Burlington Design Advisory Board

DESIGN ADVISORY BOARD

MEMORANDUM

To: The Design Advisory Board
From: Ryan Morrison, Associate Planner
RE: 323-325 College Street
Date: July 26, 2022

1 North Elevation
1/8" = 1'-0"

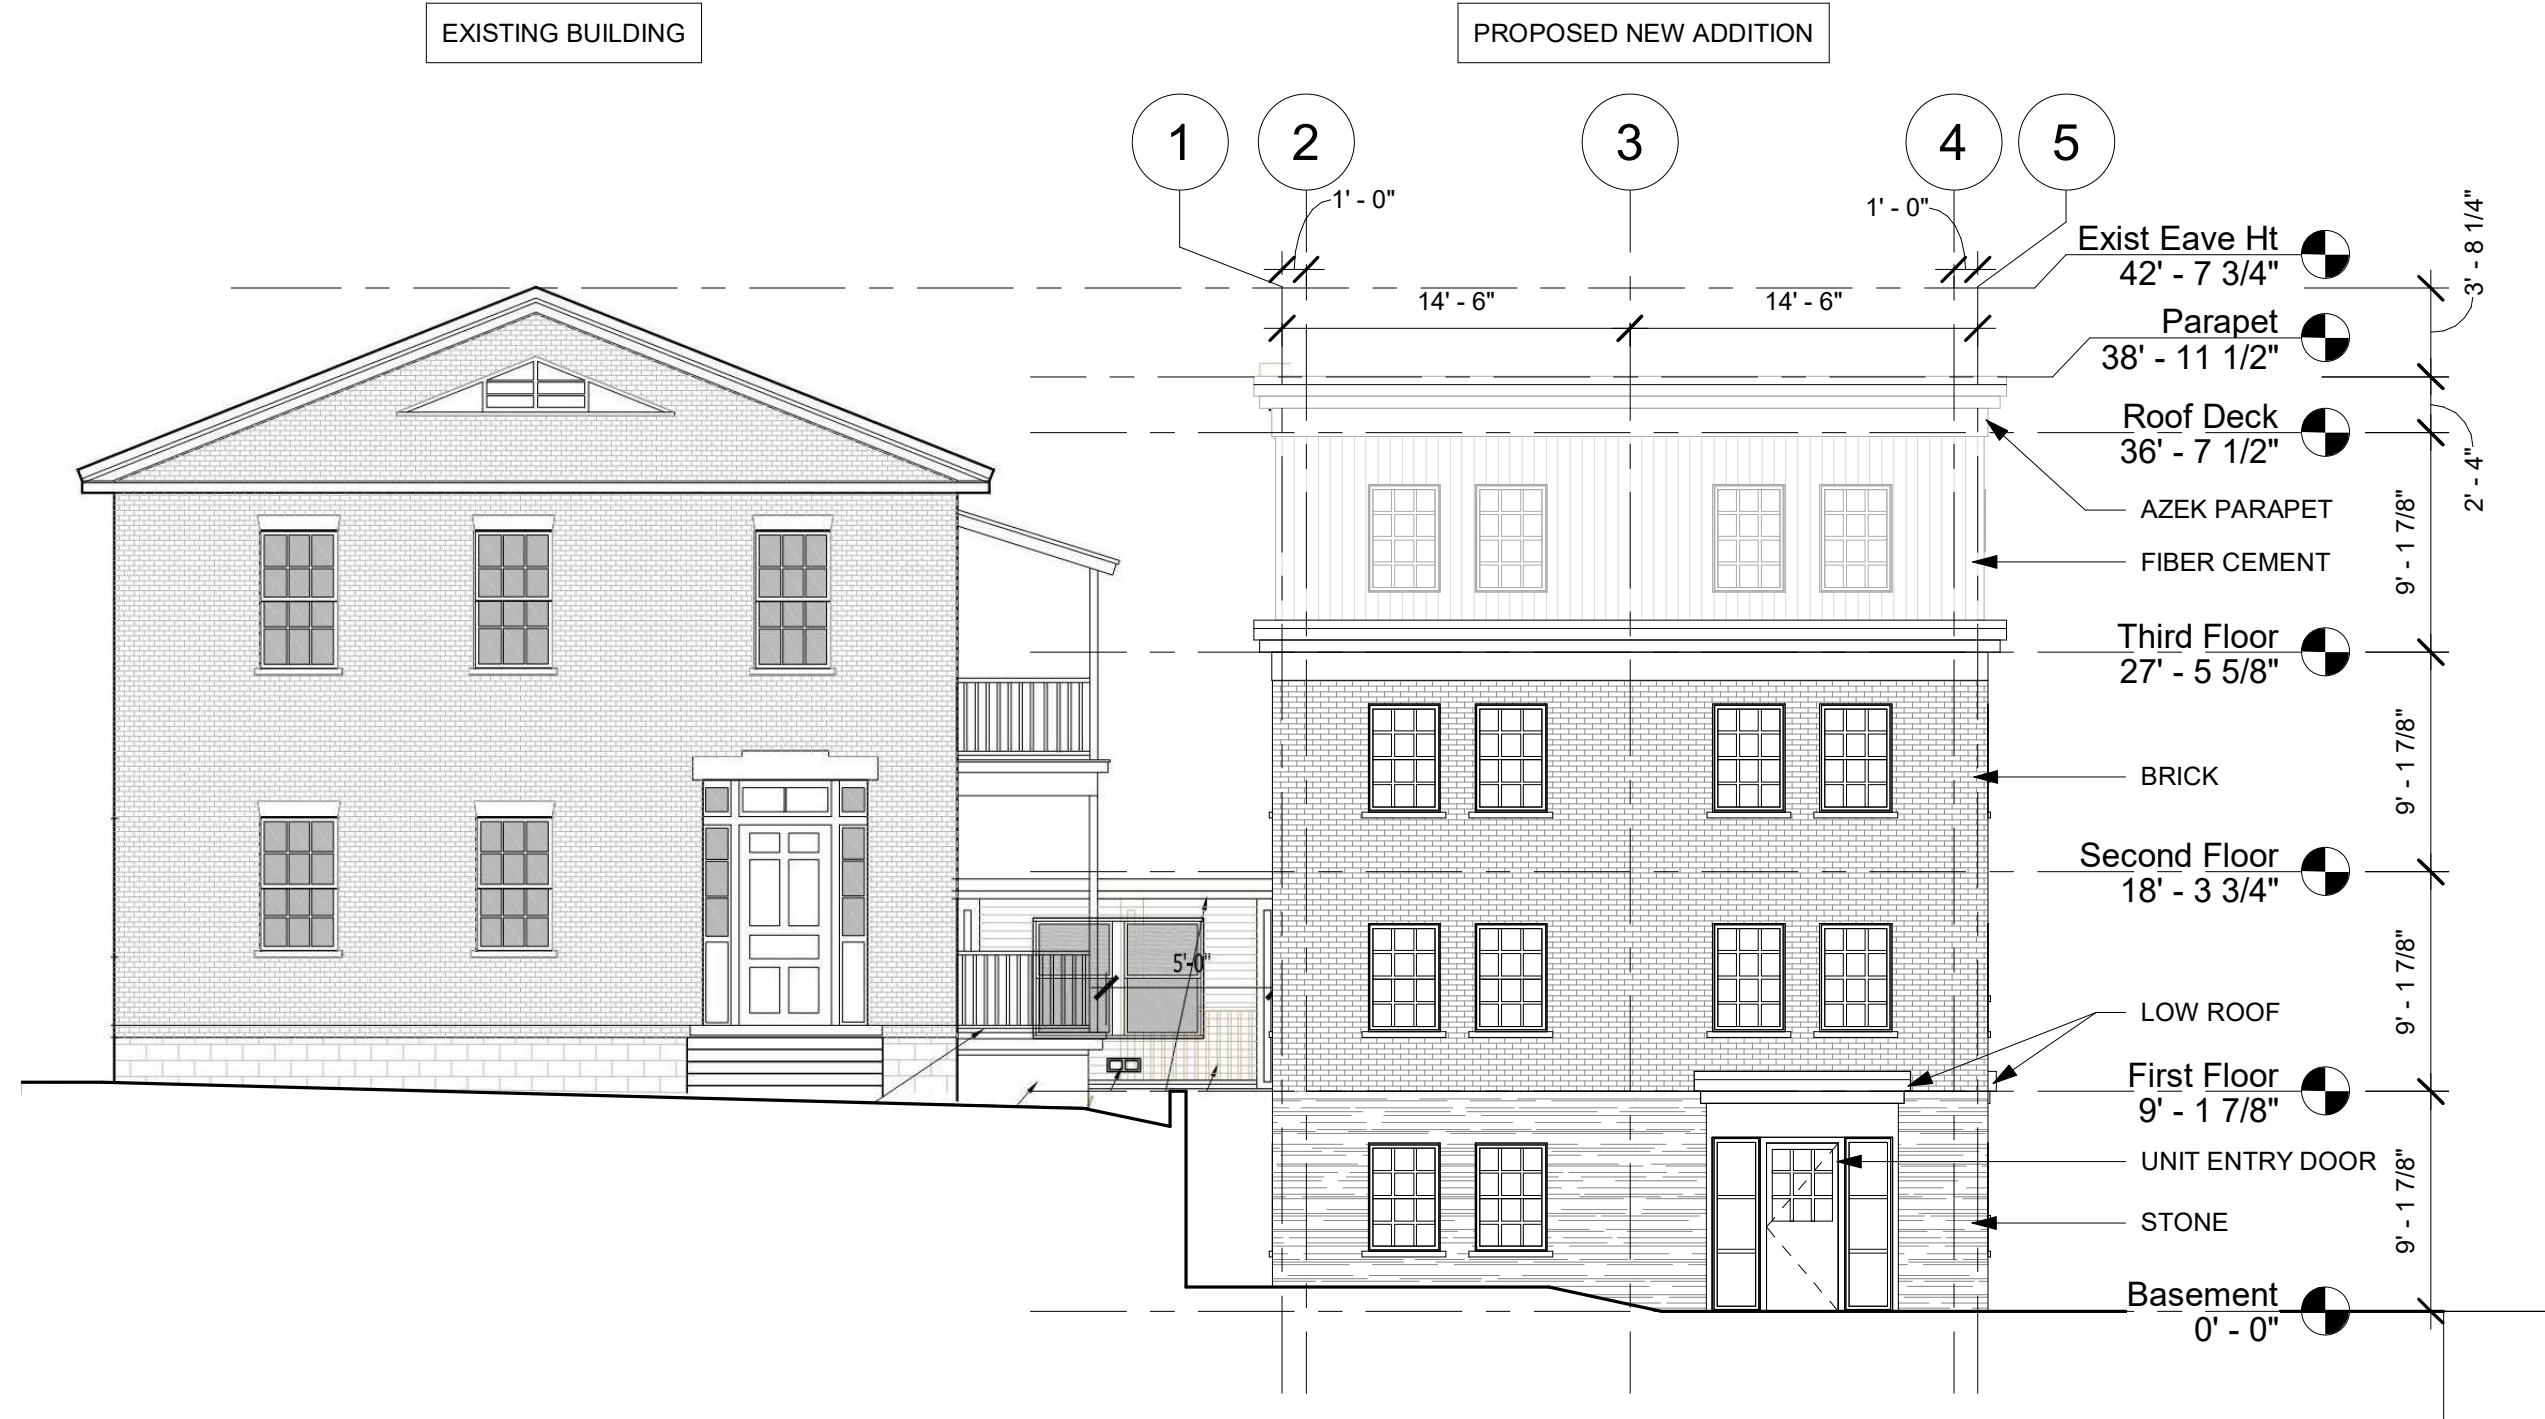
An exterior light fixture is shown above the new entry on the west elevation. The north elevation does not include a light fixture at the new entrance and should. See elevations on plan A2.

Both entrances are proposed to have exterior downlights (although lighting at the north elevation entrance needs to be included on the plans). Intercom systems are recommended to maximize personal safety.

4 West Elevation
1/8" = 1'-0"

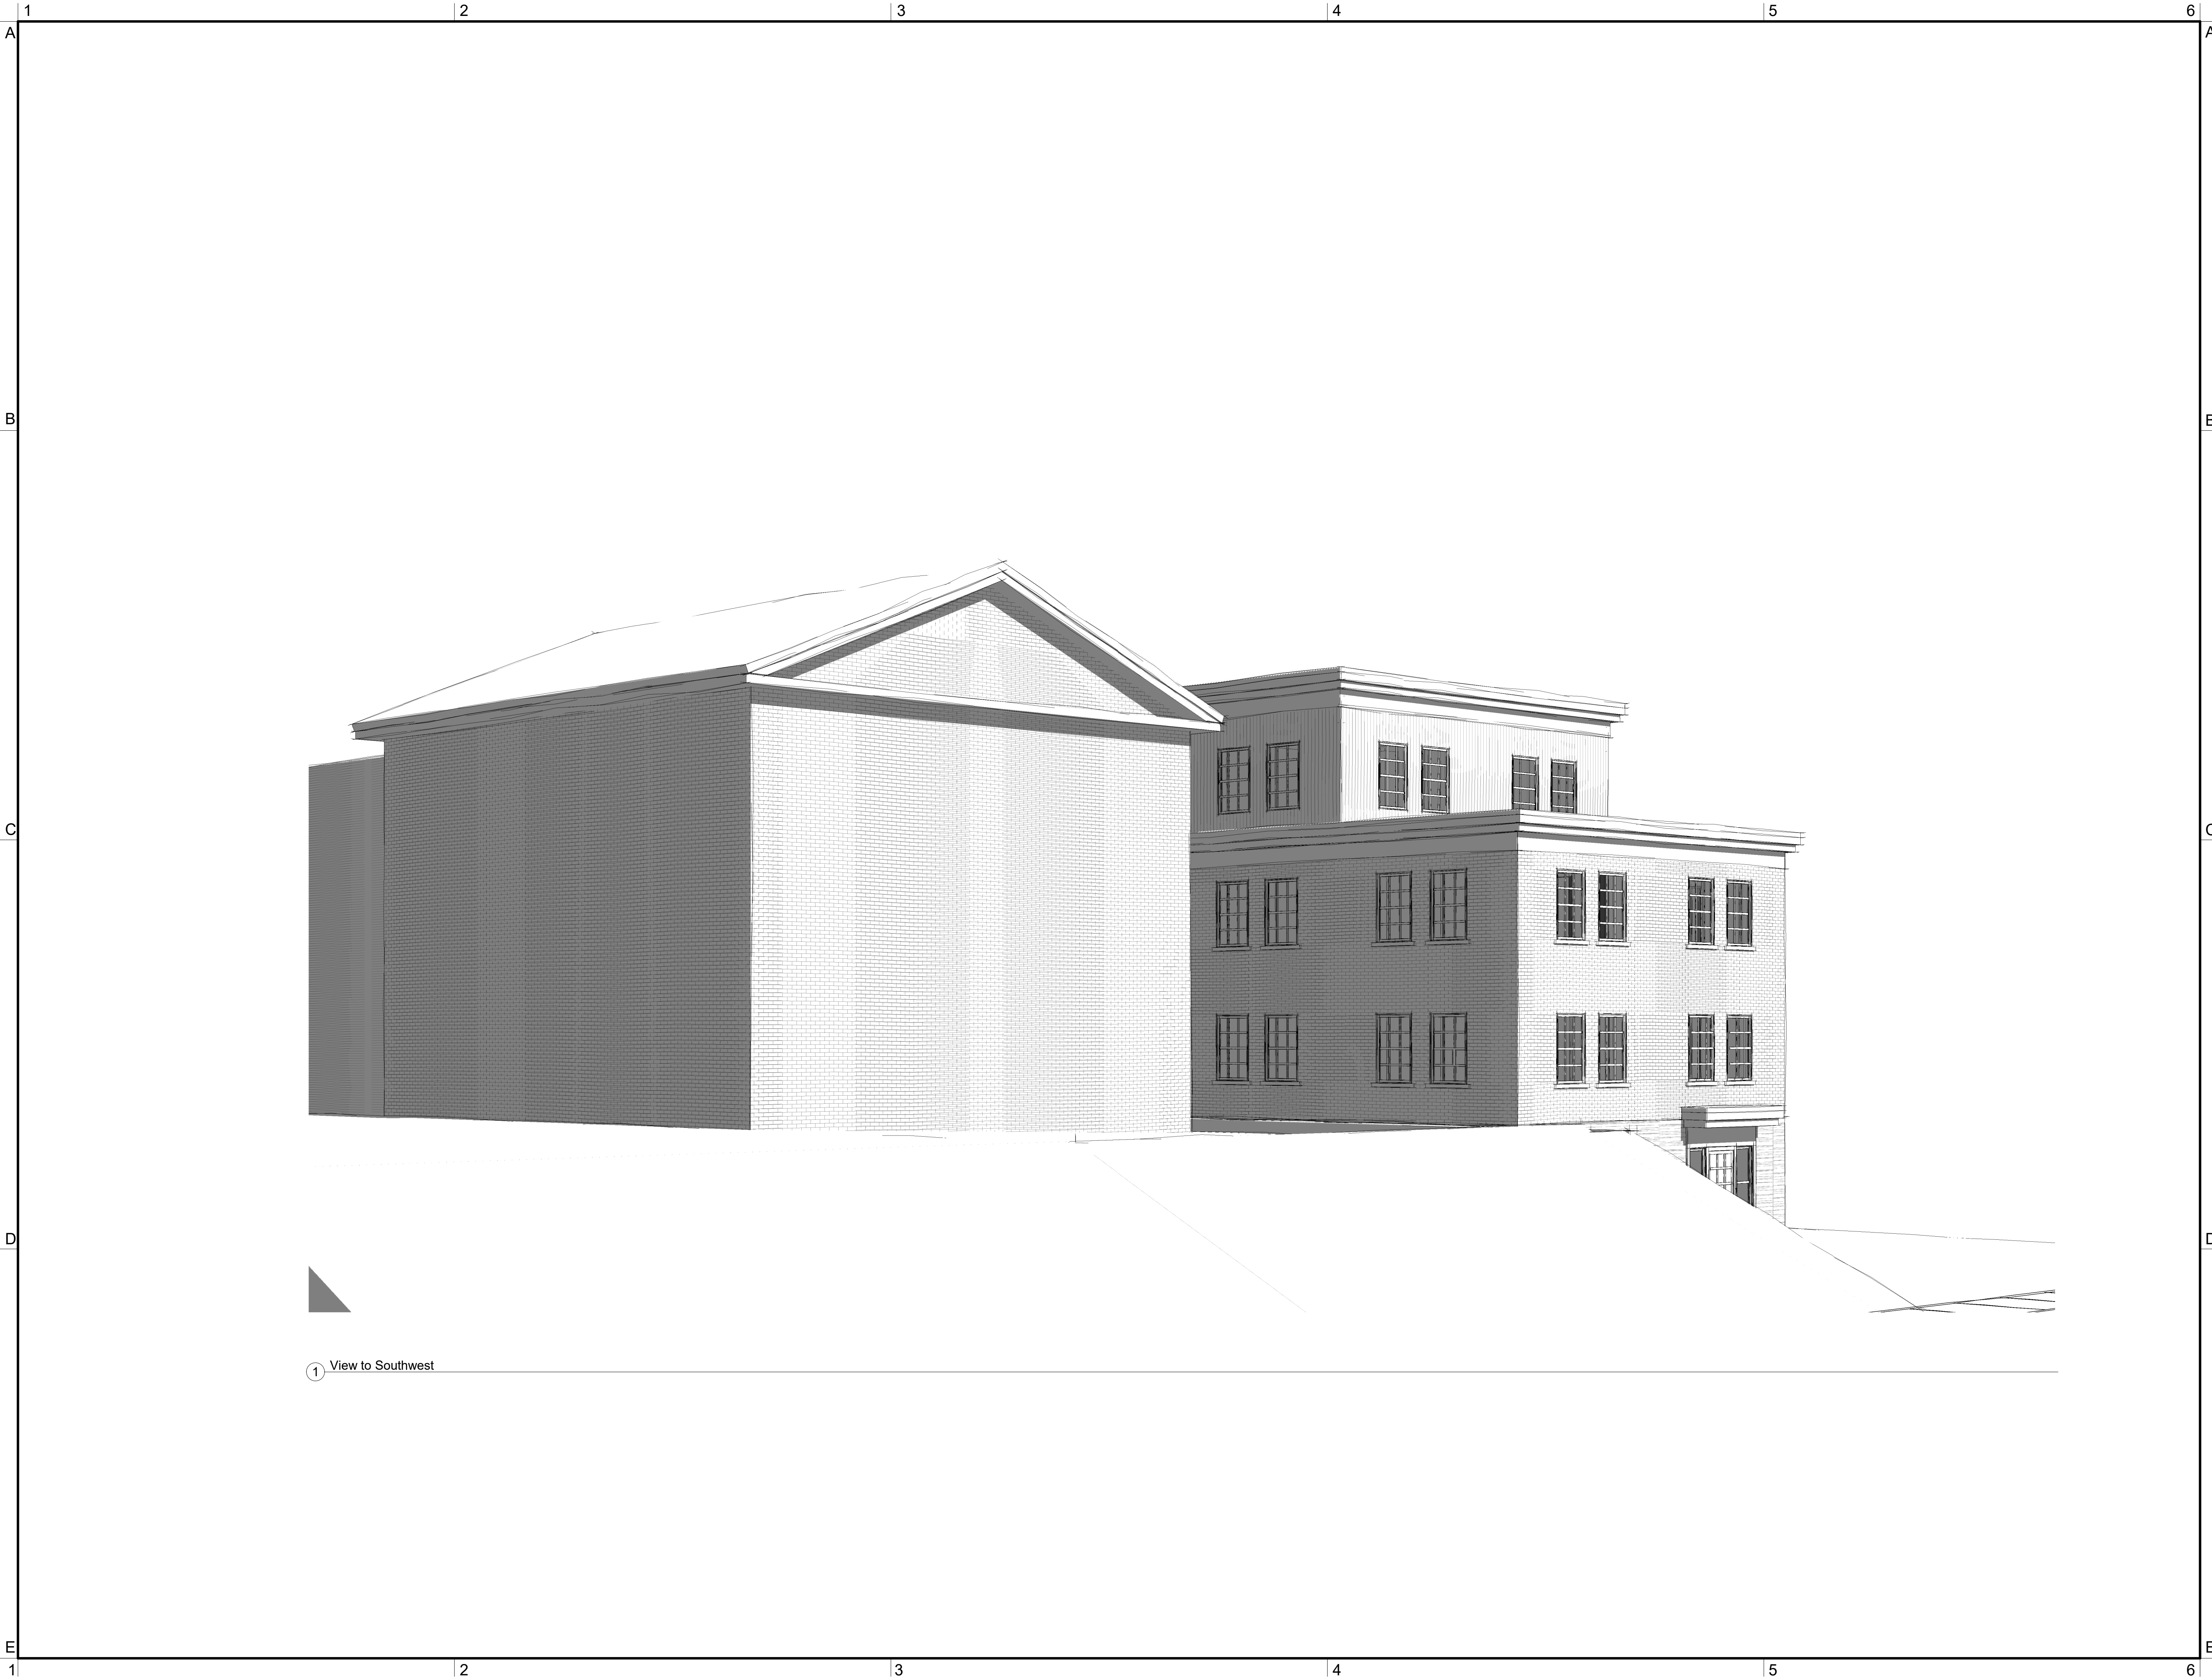
have been provided showing the west elevation. The retaining wall appears to be the same height as originally proposed and, aside from siding material, the west façade appears to be the same as originally proposed.

Doors are illustrated on both the north and west elevations (Plan A2), each of which include a canopy above. The applicant provided a snow management plan with previous applications. That should be updated for this application.

9. The applicants shall provide an updated snow management plan.
10. The westerly pedestrian entrance shall be clearly marked by differentiated ground materials and/or pavement markings to prevent vehicular blockage of the building entrance.
